AL HILLAH POLICE FIRING RANGE
AL HILLAH, IRAQ

SIGIR PA-06-076
JANUARY 08, 2007

SUBJECT: Report on Project Assessment of the Al Hillah Police Firing Range,
Al Hillah, Iraq (Report Number SIGIR-PA-06-076)

Site Photo 8. Shooter's pit at rifle firing tubes

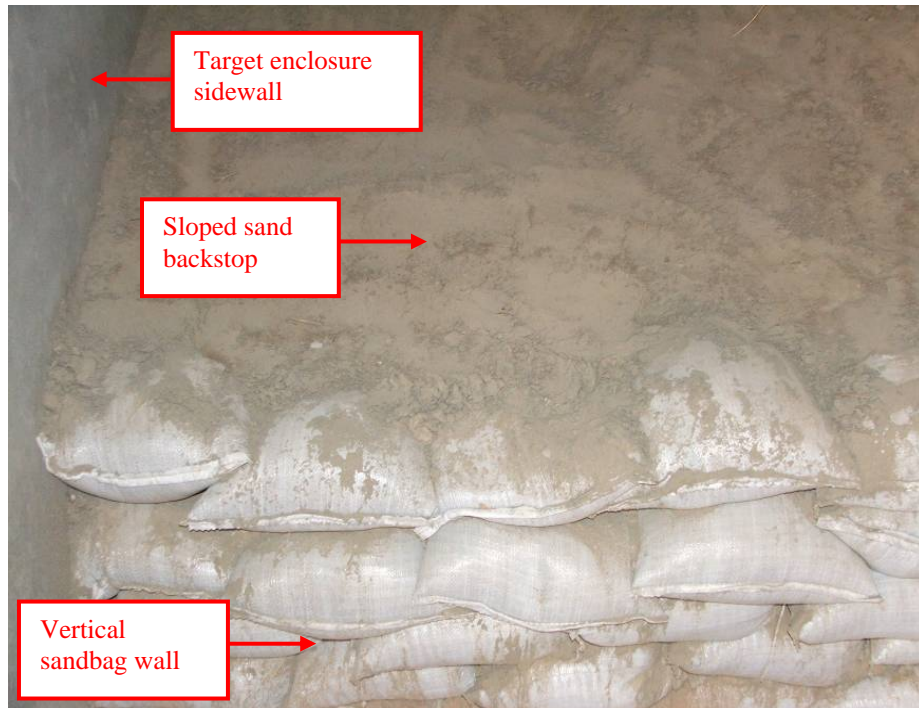
The reinforced concrete shooter's pit at the end of the firing tube was below grade so that the pit floor was 0.75 m below the floor of the firing tube. The outside dimensions of the pit were 2 m wide by 3 m long, and the pit was covered with a metal cover supported by truss frame and four steel posts. The shooter's pit contained an overhead fluorescent light fixture as well as an exterior light mounted to the outside of the metal cover frame.

Site Photo 11. Generator, electrical panel, and automatic transfer switch (ATS)

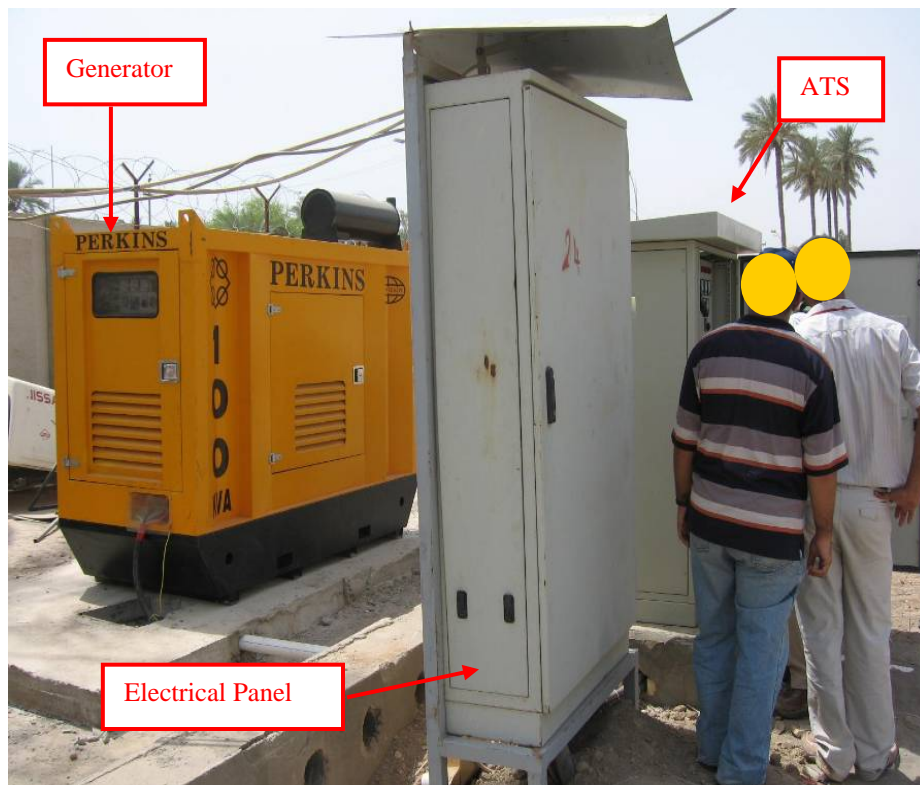
Site Photo 11 shows the 100 kVA generator installed on the concrete slab, the electrical panel, and the automatic transfer switch (ATS). The generator cover and the external fuel tank were not yet installed.

On the rear side of the electrical panel shown in Site Photo 12, we found some portions of the metal frame rusted. Additionally, the cable connecting the ATS to the panel was not enclosed in rigid conduit.
